# Town of Bennett

## REQUEST FOR PROPOSALS ADDENDUM #1

**Proposal Number:** RFP 22-010

**Proposal Title:** **Stormwater Drainage Master Plan**

## Town of Bennett Planning Area

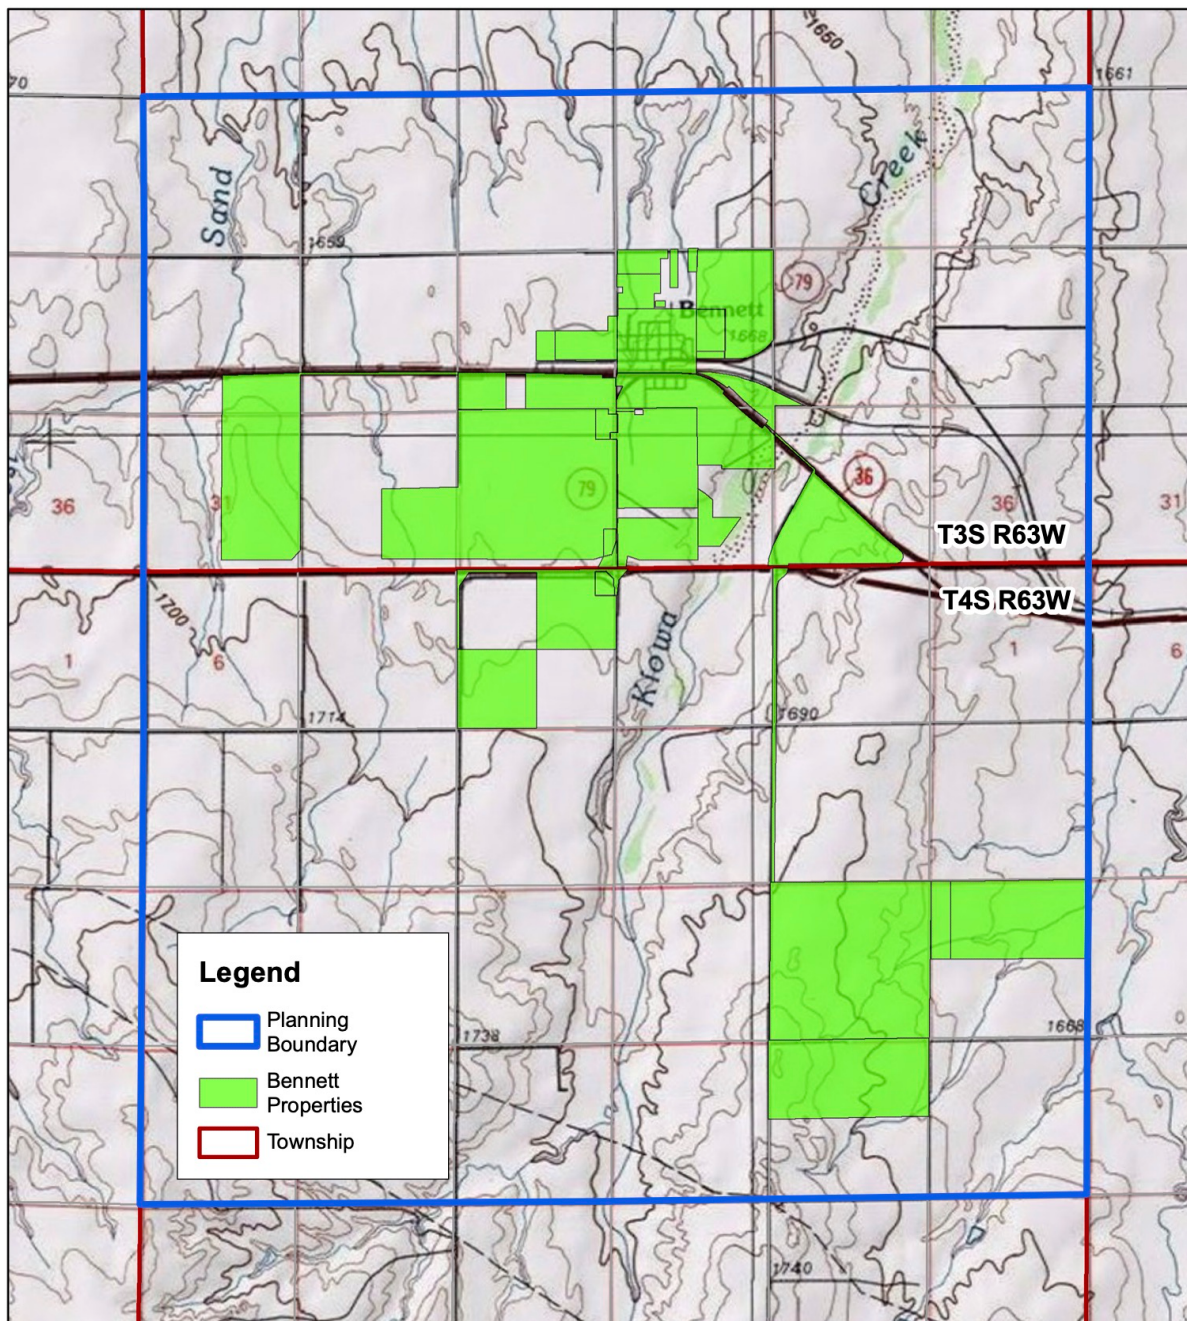
1. What is the area of interest for this Master Plan? **The "Planning Boundary" blue boxed area on the included map below is the Area of Interest for this Master Plan. It encompasses an area 6 miles x 7 miles, covering 42 square miles in total.**
